FELDMAN KIA JSP25-24

Consideration of the request of Feldman Automotive for Preliminary Site Plan and Storm Water Management Plan. The subject property is zoned B-3 with a Planned Rezoning Overlay (PRO), which conditions development to the terms of a PRO Plan and Agreement. The applicant is proposing to develop a Kia dealership.

PLANNING REVIEW

PLAN REVIEW CENTER REPORT

4 DUMPSTER ENCLOSURE DETAIL

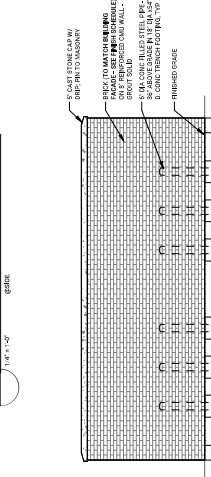
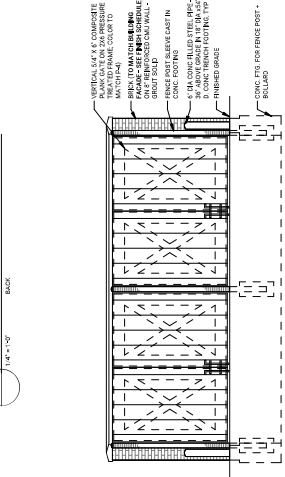
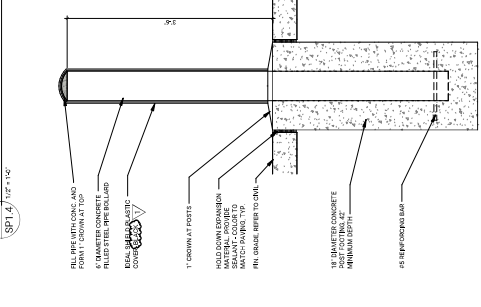
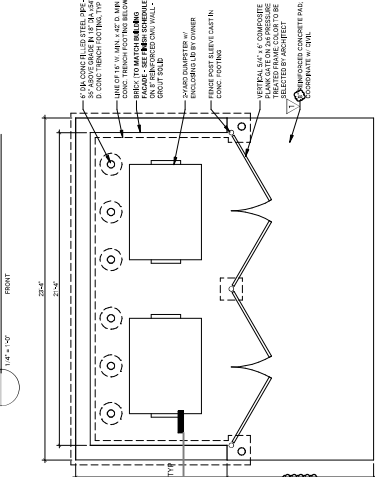
35. Provide Dumpster Pad details on the plans, which shall be 8" concrete on 8" 21AA aggregate base. Note: The dumpster pad shall extend a minimum of 10' beyond the dumpster enclosure.

Response – Will comply. See revised SP1.4 and typical paving cross sections included in the Civil drawings.

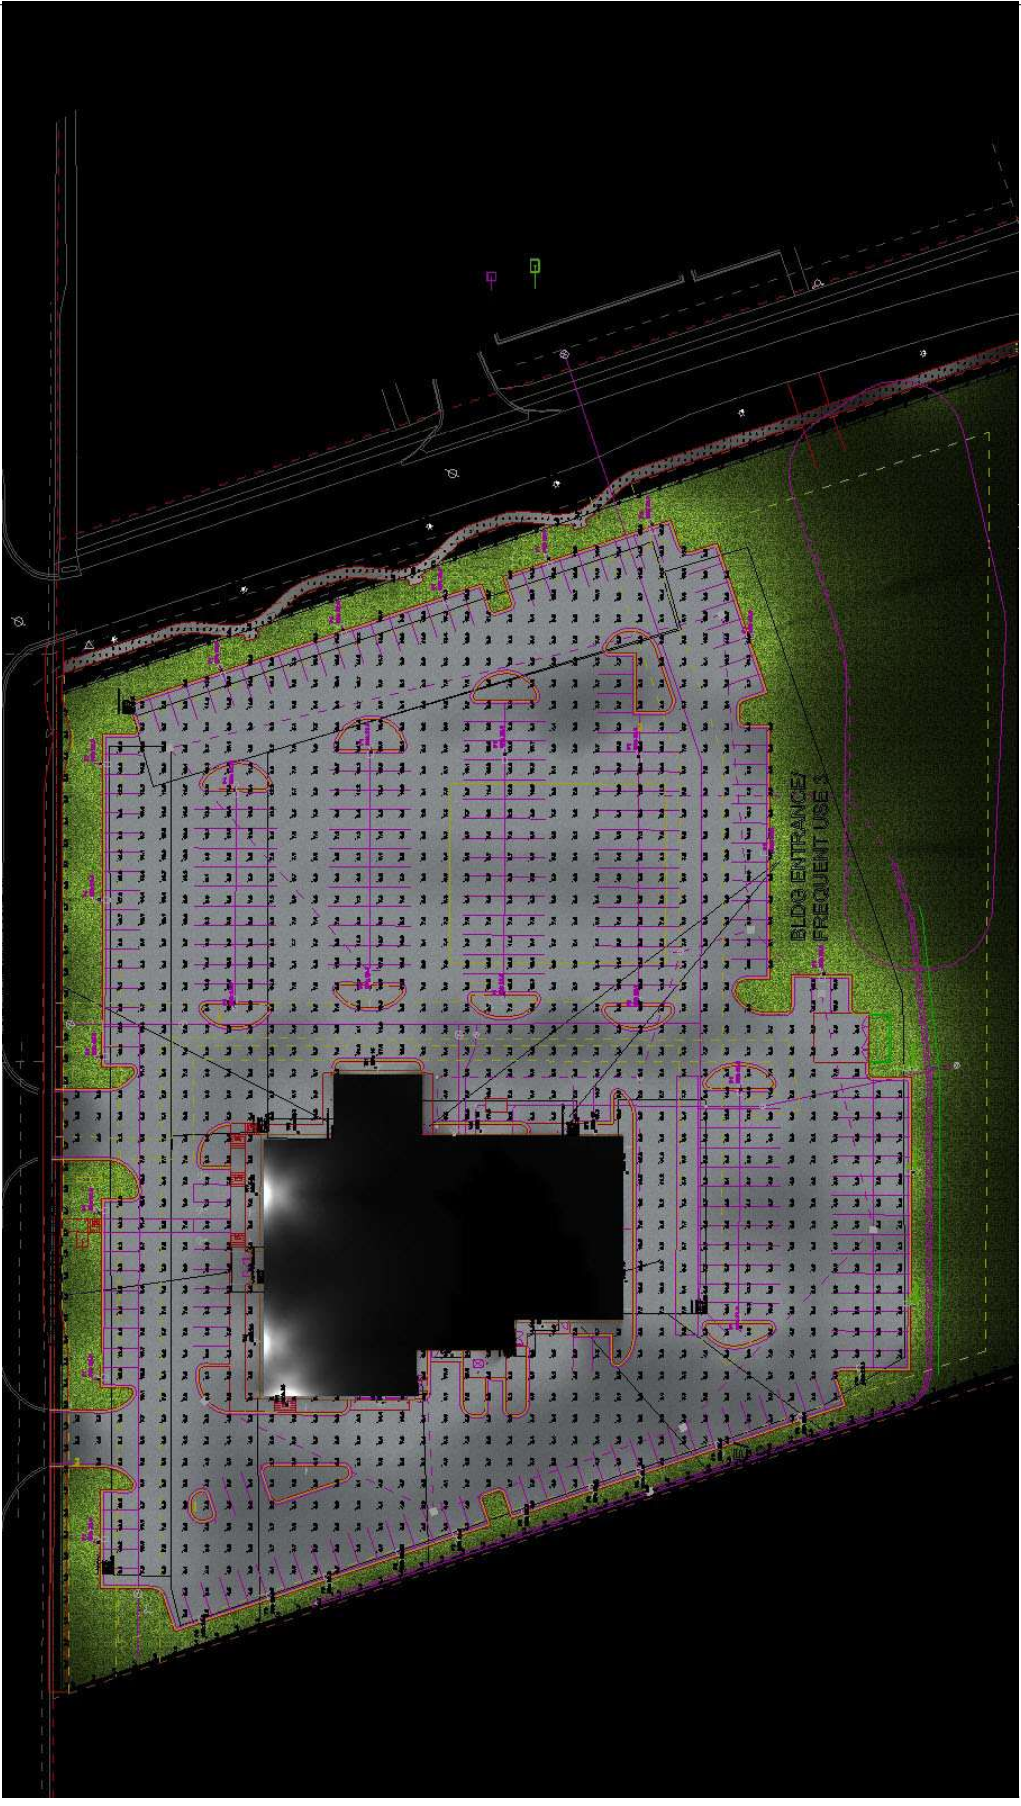
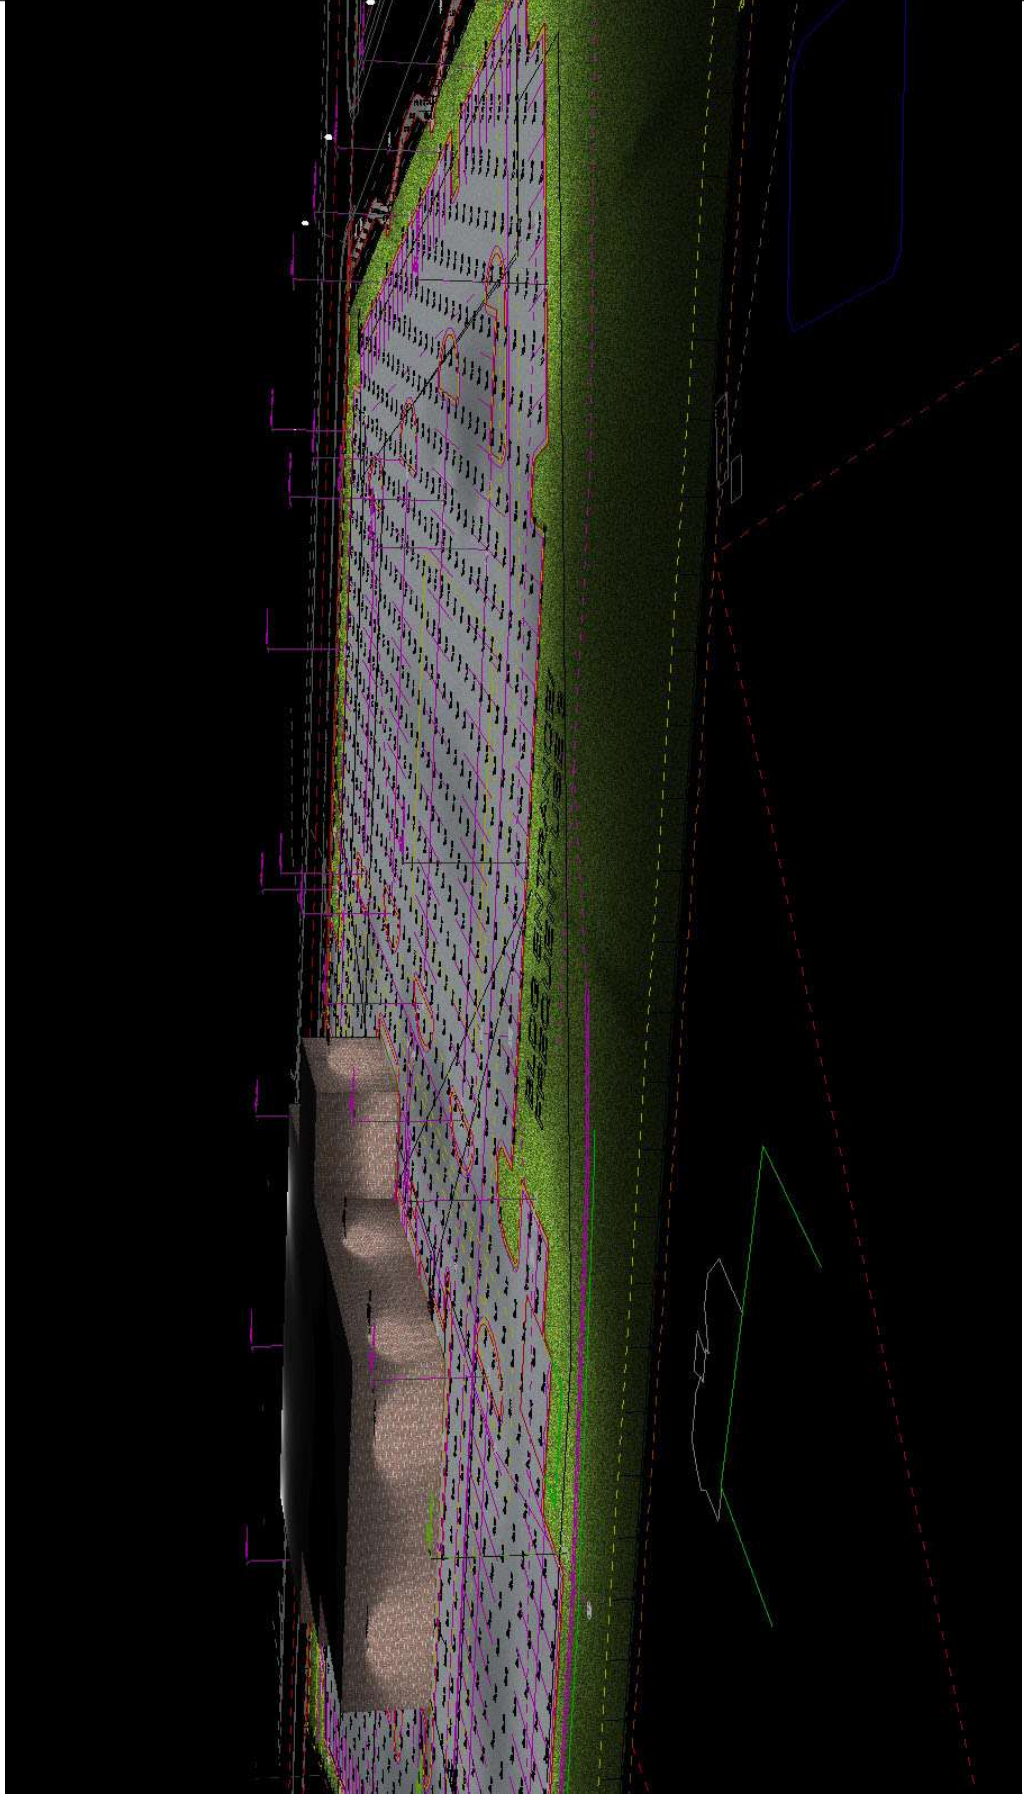
- 2. Comment: Lighting: Light levels on sheets P2 through P4 are unreadable. See the Planning Chart for additional details that must be provided to address lighting requirements before the Final Site Plan can be approved.**

- **Comment: Sheet 2 of 4 needs clarification. Provide a key to meaning of light gray vs black photometric levels, remove overlapping labels, some of which are upside down making plans unreadable.**
